Recall Bulletin

PRODUCT SAFETY RECALL

SUBJECT: Ignition Key

MODELS: 2010-2014 Chevrolet Camaro

3947698

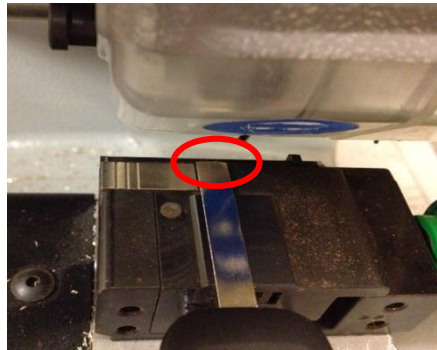
NOTE: The key blank should fit into the Jaw as shown in the picture. Make sure there is no gap in the area circled in the picture. Remove the guard if necessary.
